Groundwater Application Review Summary Form

Application # G- 19027

GW Reviewer Joe Kemper Date Review Completed: 6/13/2023

PUBLIC INTEREST REVIEW FOR GROUNDWATER APPLICATIONS

Stream Depletion Modeling (Hunt, 1999)

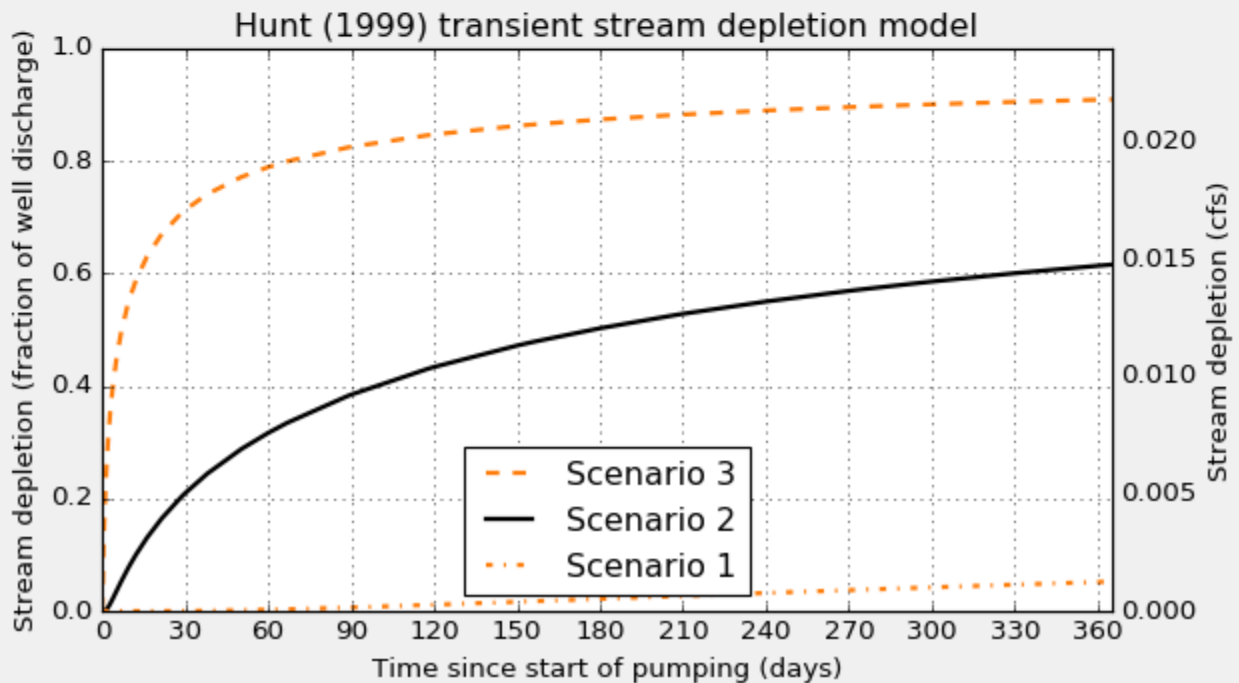
Basis for impact evaluation: Stream depletion to Williams Creek is estimated using the Hunt (1999) analytical model using parameters representative of bulk aquifer properties. A pumping rate of 0.024 cfs is used to represent the total volume of water that would be pumped from JOSE 9971 under G-19027 and Certificate 66521 (17.5 AF) pumped over 365 days.
